DHCD – Division of Building and Fire Regulation
2006 Code Change Cycle

COMPILATION DOCUMENT
(of all code changes received with staff evaluations)

**USBC – Virginia Construction Code
Code Change No. C-310.6(R602.3)**

**USBC – Virginia Construction Code
Code Change No. C-310.6(R602.10)**

Job	Truss	Truss Type	Qty	Ply	Job Reference (optional)
CHUCKB	T1	ATTIC	1	1	
BSOP, PETERSBURG, VA 23804, BONNIE LOGAN			6,400 s Sep 7 2006 MiTek Industries, Inc. Tue May 29 13:01:06 2007 Page 1

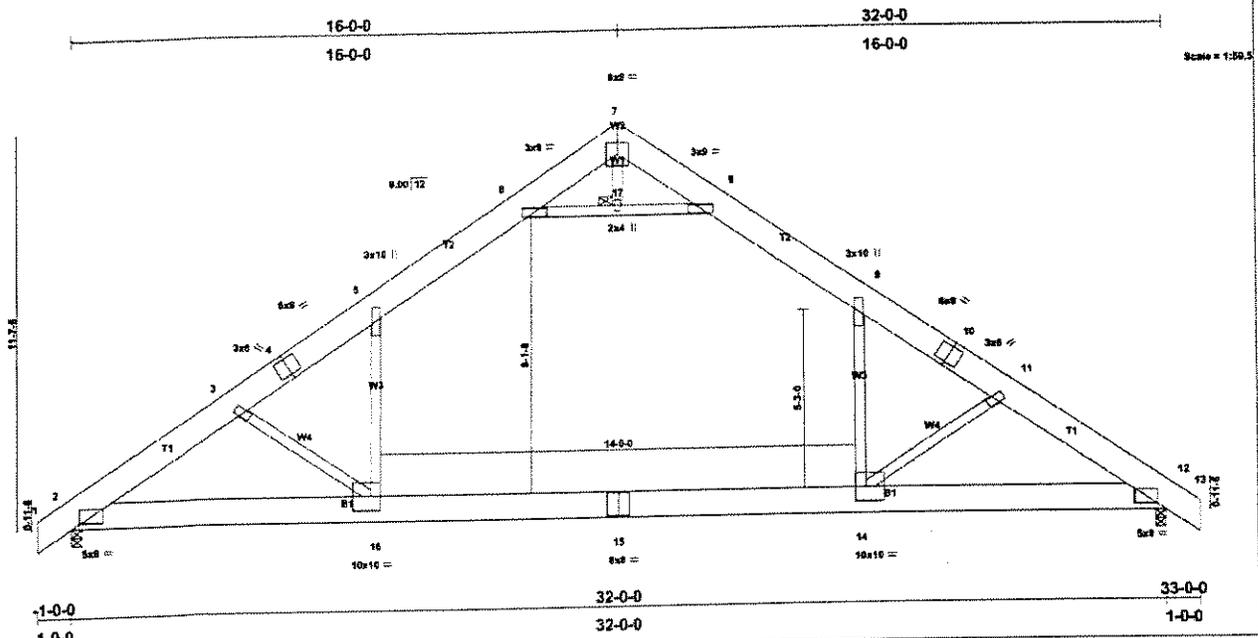
Because the calculations show the 32 feet width (with 5 foot knee walls each side) is about the limit for the studs of a two-story house with trusses, we have the limit of "70% of the total width of the structure" requirement. (i.e. the occupiable space utilizes about 22/32 or 70% of the total width of the structure.).

FIGURE R602.10.1.3(1)
BRACED WALL PANELS AND BRACED WALL LINES

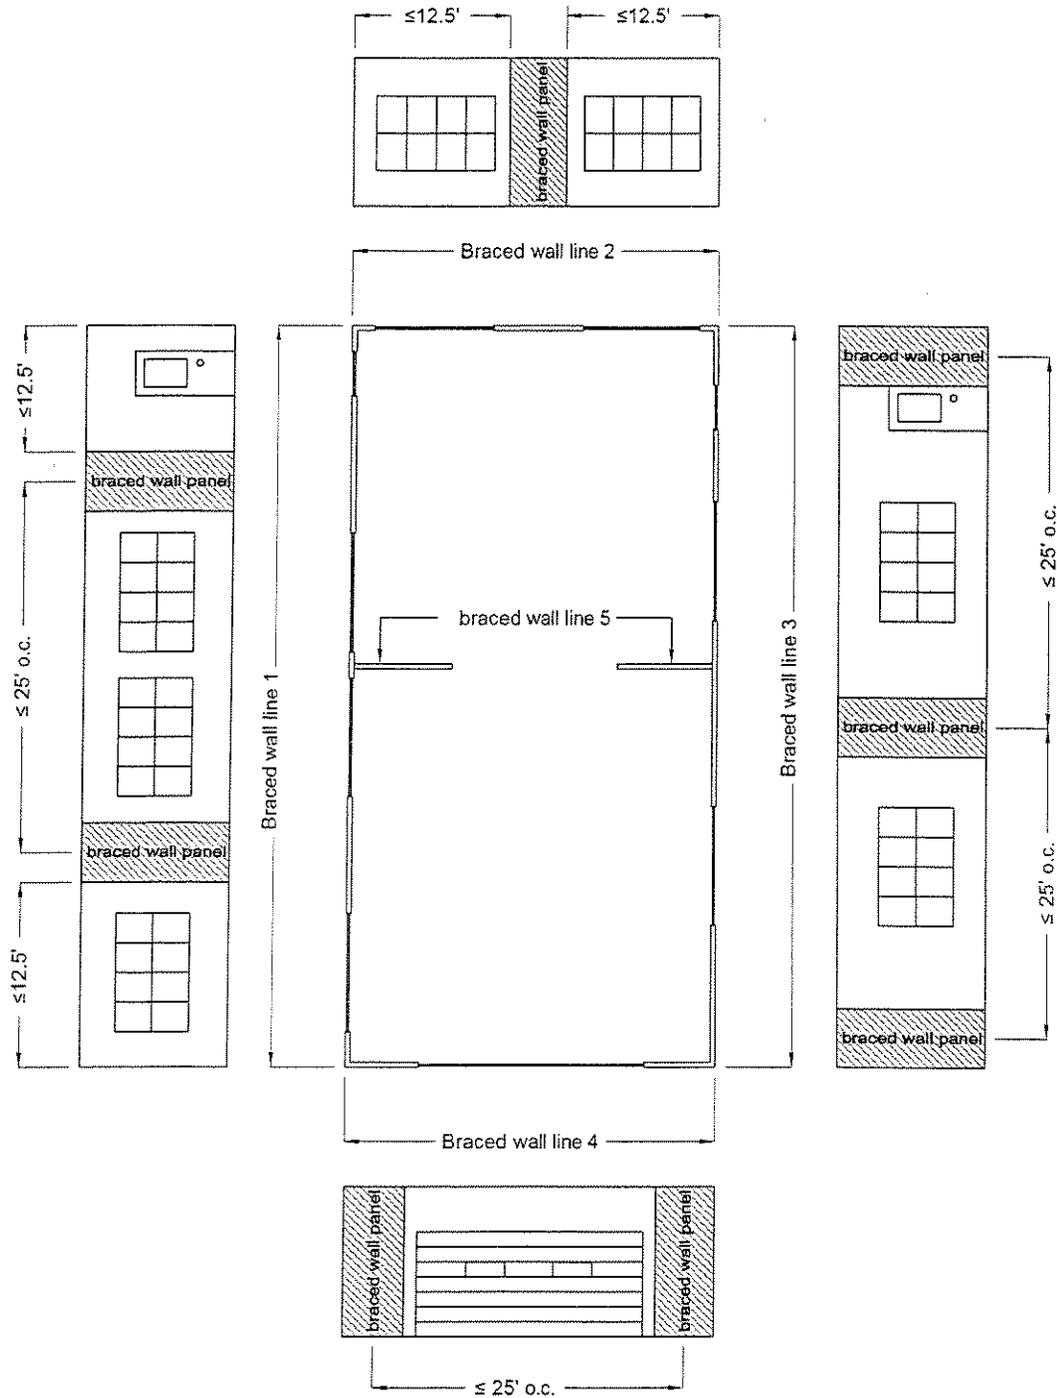
R602.10.1.3 Braced wall panel location. Braced wall panels shall be located at least every 25 feet (7620 mm) on center and shall begin no more than 12.5 feet (3810 mm) from each end of a braced wall line or its projection as shown in Figure R602.10.1.3(1) and Figure R602.10.4, but not less than the percentages given in Table R602.10.1.5. Braced wall lines with continuous sheathing shall conform to the additional requirements of Section R602.10.3.3.

FIGURE R602.10.1.3(2)
OFFSETS PERMITTED FOR BRACED WALL PANELS ALONG A BRACED WALL LINE

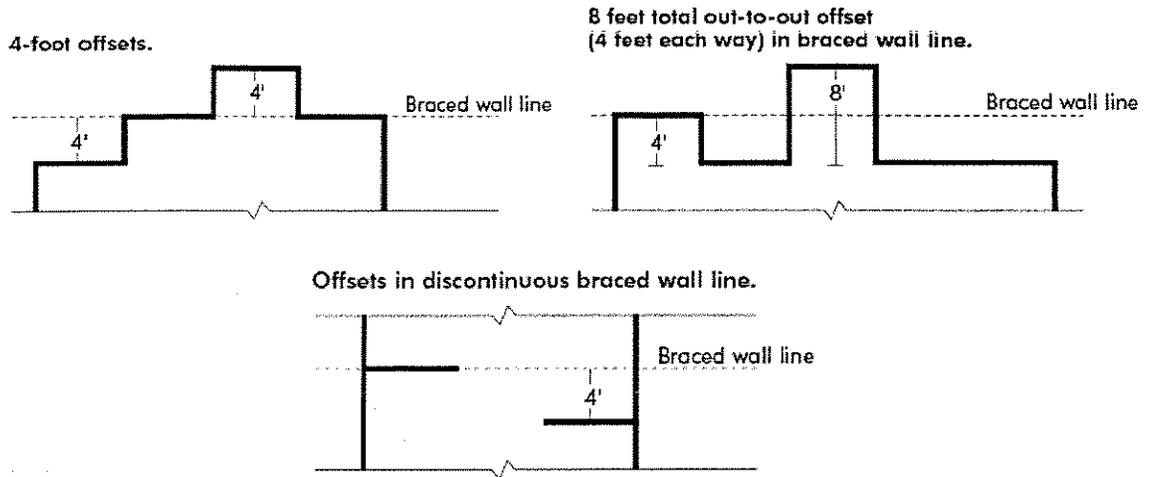
All braced wall panels shall be permitted to be offset out-of-plane from the designated braced wall line up to 4 feet (1219 mm) provided the total out-to-out offset in any braced wall line is not more than 8 feet (2438 mm) as shown in Figure R602.10.1.3(2).

FIGURE R602.10.1.4
ANGLED CORNERS

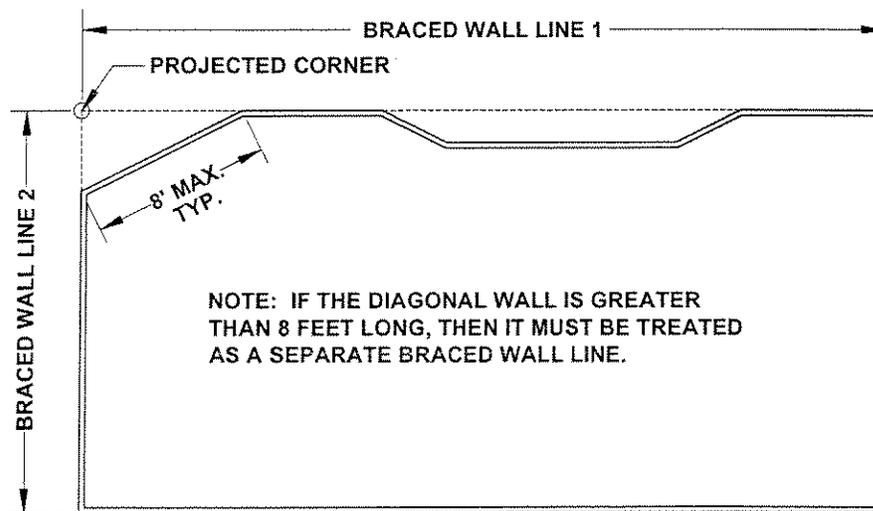
R602.10.1.4 Angled walls. The walls of a braced wall line shall be permitted to angle out of plane for a maximum diagonal length of 8 feet (2438 mm). Where the angled wall occurs at a corner, the length of the braced wall line shall be measured from the projected corner as shown in Figure R602.10.1.4. Where the diagonal length is greater than 8 feet (2438 mm), it shall be considered its own braced wall line.

FIGURE R602.10.3.1
METHOD CS-PF: CONTINUOUS PORTAL FRAME BRACED WALL PANELS

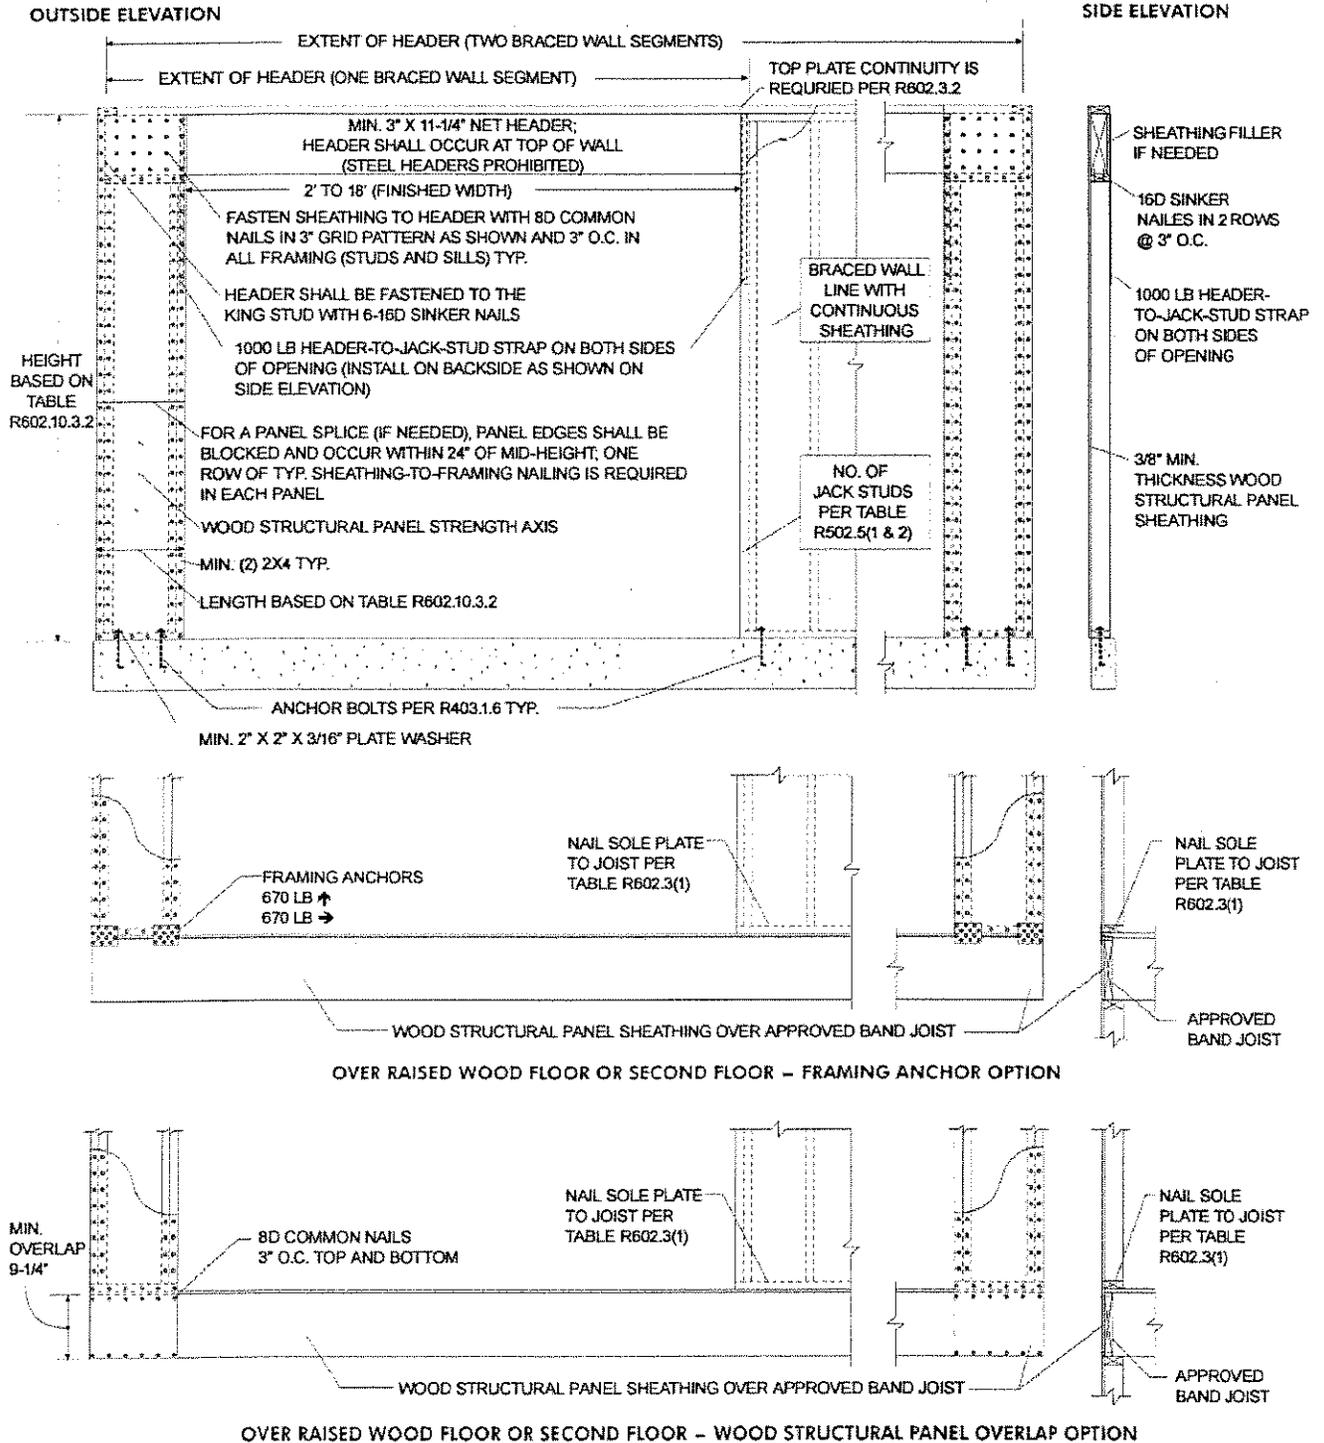
- b. The number of continuous portal frame panels in a braced wall line shall not exceed four. Continuous portal frame panels shall not be stacked vertically in multi-story buildings.

FIGURE R602.10.3.3(1)
TYPICAL EXTERIOR CORNER FRAMING FOR CONTINUOUS SHEATHING

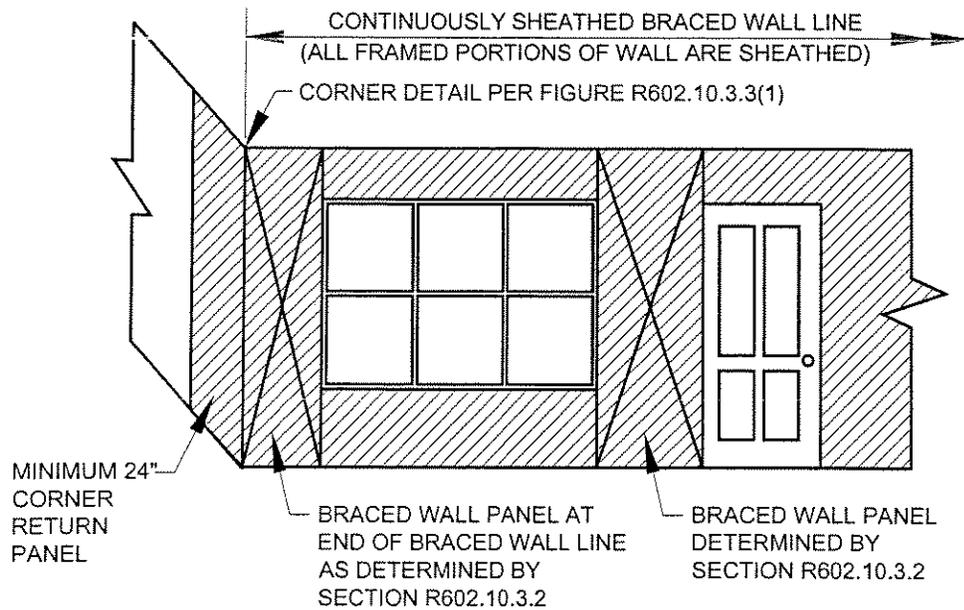
A minimum 24 inch (610 mm) wood structural panel corner return shall be provided at both ends of a braced wall line with continuous sheathing in accordance with Figures R602.10.3.3(1) and R602.10.3.3(2). In lieu of the corner return, a hold-down device with a minimum uplift design value of 800 lb (3560 N) shall be fastened to the corner stud and to the foundation or framing below in accordance with Figure R602.10.3.3(3).

**FIGURE R602.10.5(1)
BRACED WALL PANEL CONNECTION WHEN
PERPENDICULAR TO FLOOR/CEILING FRAMING**

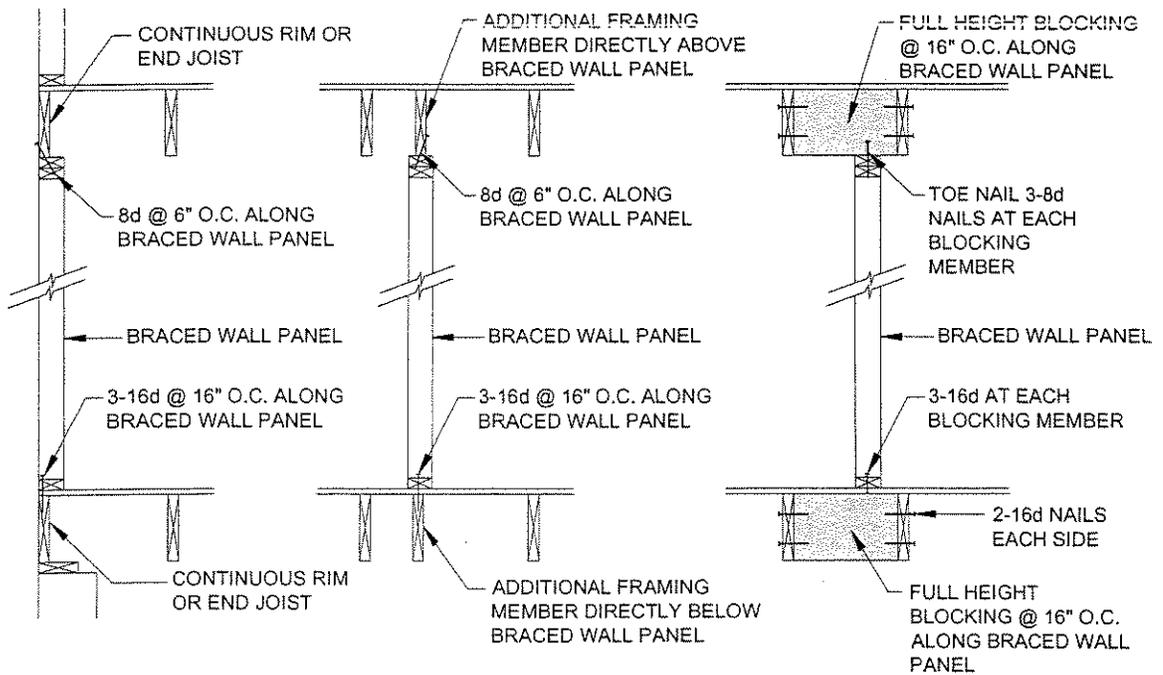
1. Where framing is perpendicular to a braced wall panel above or below, a rim joist or blocking shall be provided along the entire length of the braced wall panel in accordance with Figure R602.10.5(1). Fastening of wall plates to framing, rim joist or blocking shall be in accordance with Table R602.3(1).

**FIGURE R602.10.6
MASONRY STEM WALLS SUPPORTING BRACED WALL PANELS**

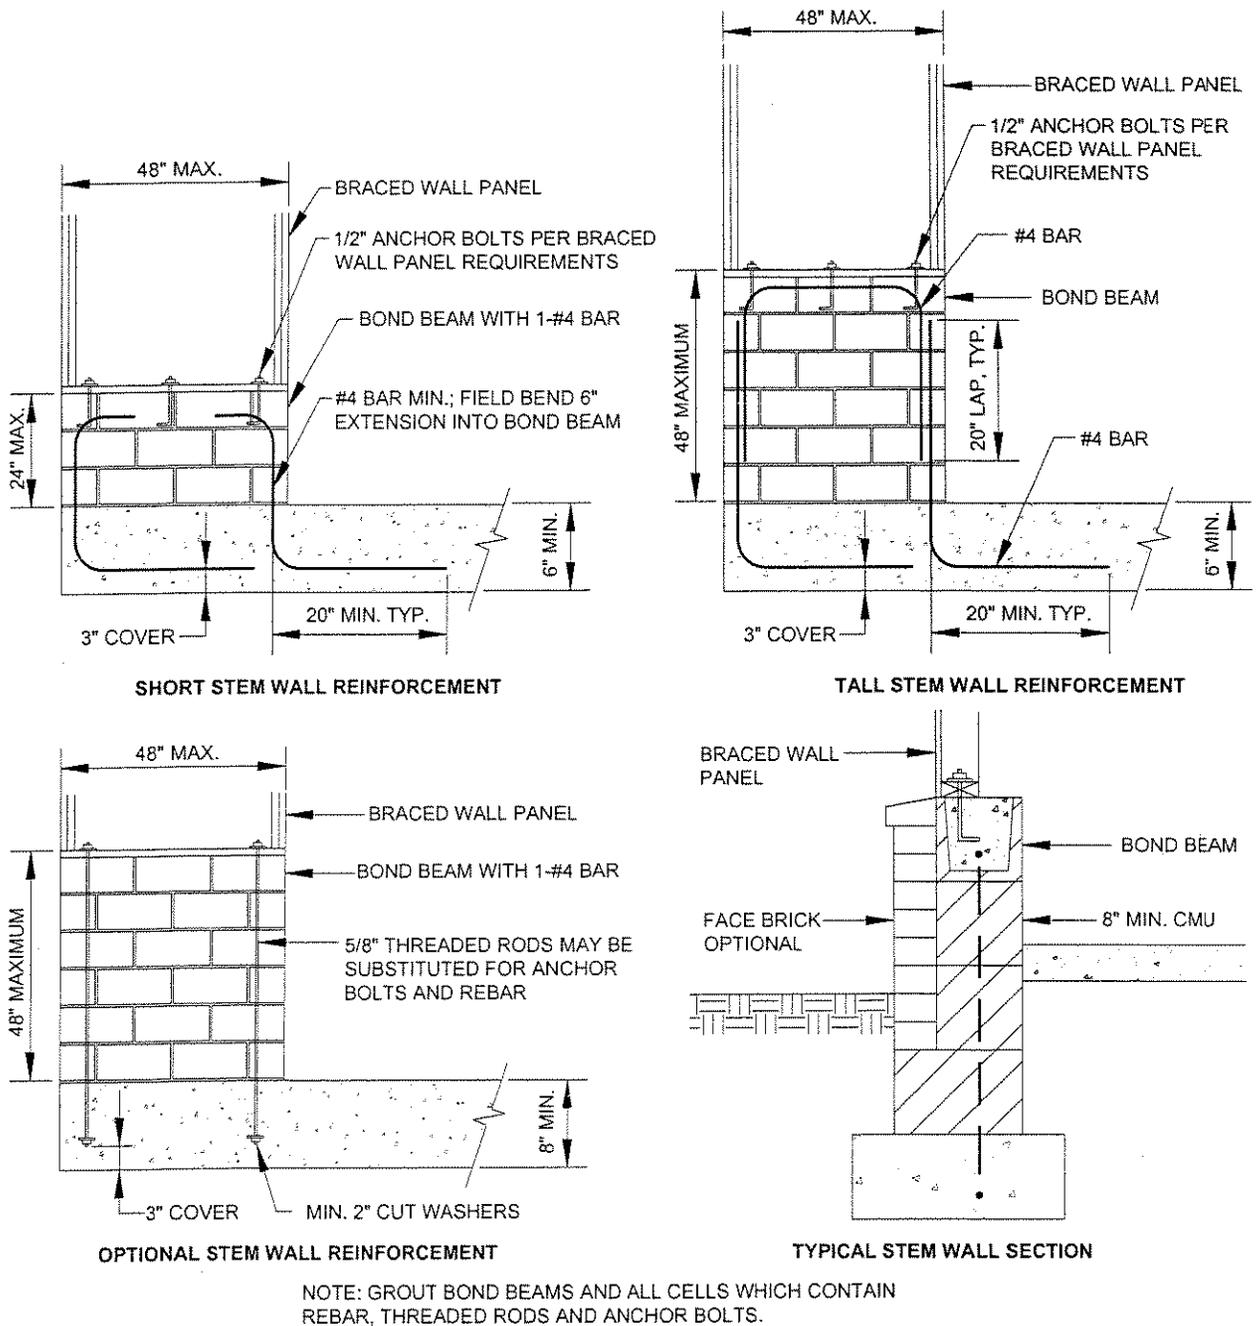
1. Braced wall panels shall be permitted to be supported on cantilevered floor joists meeting the cantilever limits of Section R502.3.3 provided joists are blocked at the nearest bearing wall location.
2. Elevated post or pier foundations supporting braced wall panels shall be designed in accordance with accepted engineering practice.
3. Masonry stem walls supporting braced wall panels with a length of 48 inches (1220 mm) or less shall be reinforced in accordance with Figure R602.10.6. Masonry stem walls supporting braced wall panels with a length greater than 48 inches (1220 mm) shall be constructed in accordance with Section R403.1. Braced wall panels constructed in accordance with Methods ABW and IPF shall not be permitted to attach to masonry stem walls.

Note: Front wall contains the garage opening.

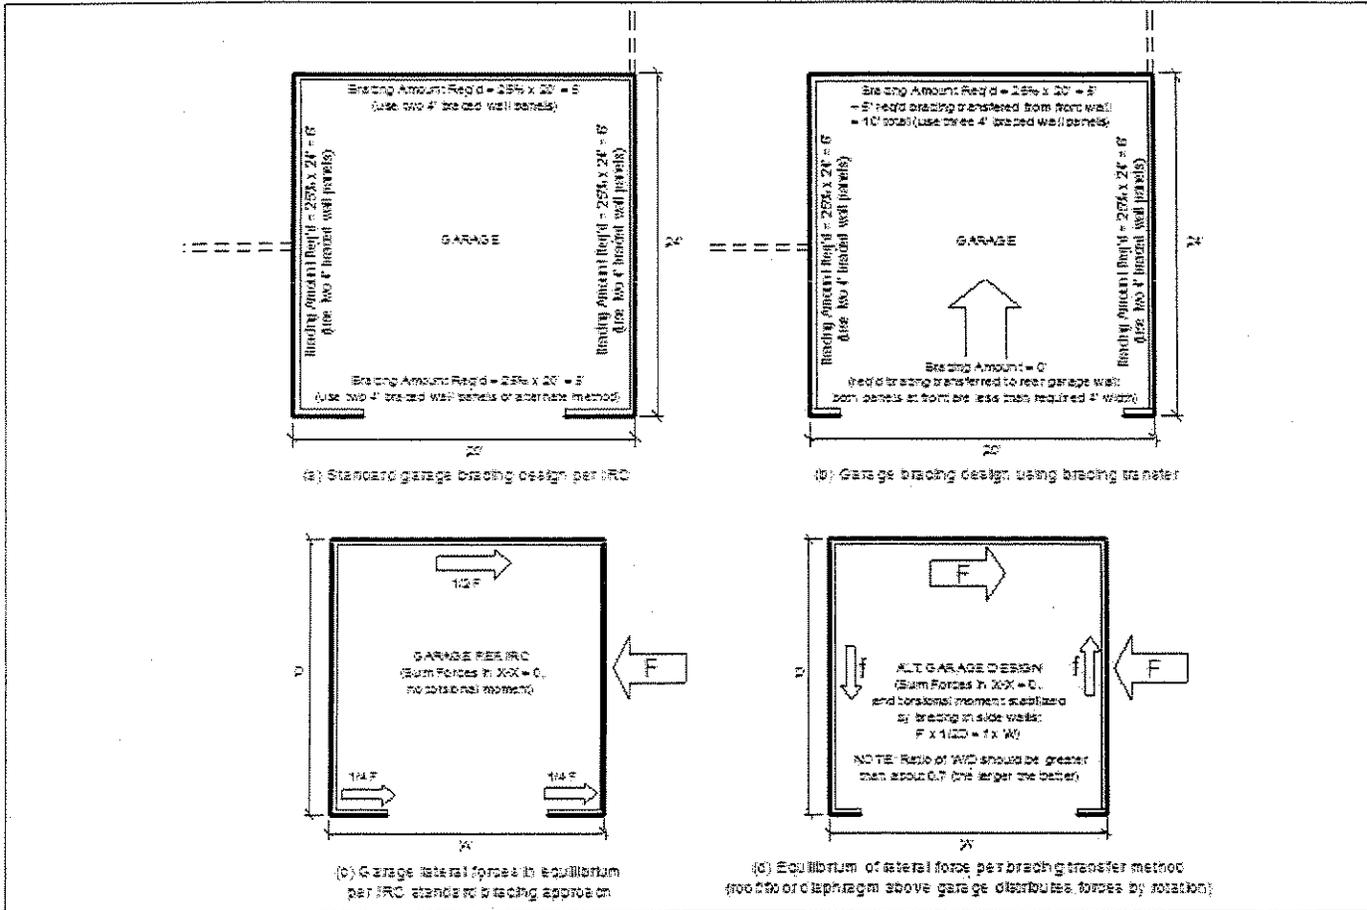
The second exception (see also the Figure below for example) provides a means of bracing a garage as a structural unit and does not require bracing on the garage opening wall line. This requires that the bracing amount is effectively doubled on the rear garage wall (opposite from the garage opening) to provide equivalent resistance to the direct shear load. Because this arrangement creates a torsional loading condition, the side walls must also be adequately braced to resist the torsional or twisting load that is created by way of a "force couple". This is simply achieved by bracing both side walls in compliance with bracing requirements of Section R602.10.1 and by limiting the plan aspect ratio of the garage (depth to width) as described in the proposal. This method is not new and has been in use for some time, but only by way of an engineered solution for individual buildings. Because of its simplicity and common need/use, this approach is more effectively addressed as a prescriptive solution in the code. This exception does not reduce bracing strength but achieves compliance through a different approach to building stability and lateral load analysis that more accurately distributes lateral load based on relative resistance of shear walls through floor and roof systems that act as rigid diaphragms based on whole building testing. The approach is explained and illustrated below.

Consider a garage of width, W, and Depth, D with a garage opening located in the width direction (see Figure below). The lateral load acting parallel to the garage opening and rear walls is resisted directly by wall bracing in the rear garage wall only (bracing value of narrow walls to either side of garage opening is considered negligible). This realistic loading condition creates a force couple or moment that attempts to rotate the garage opening wall about the rear wall that contains all of the shear resistance (bracing). The magnitude of this force couple is $V \times \frac{1}{2} D$ where V is the lateral load force (and is equivalent also to the amount of load resistance required in the way of wall bracing). While the direct shear force is resisted by the rear garage wall, the force couple is resisted by the side walls which produce a resisting force couple with a magnitude of $V_{sw} \times W$. Therefore, to maintain equilibrium of forces $V_{sw} \times W$ must equal or exceed $V \times \frac{1}{2} D$, where V_{sw} is the bracing resistance provide by the garage sidewalls. Setting these equal and solving for V_{sw} (required shear resistance in the side walls to resist the load force couple), the following design equation is determined to check equilibrium against the force couple or torsional moment created by this condition:

As shown above, when D/W is approximately 1.2 or less, this proposal that permits transfer of bracing from the garage opening wall to the rear garage wall (effectively doubling bracing amount in the rear garage wall) results in a structurally stable building or garage provided side walls area also braced in accordance with the code.
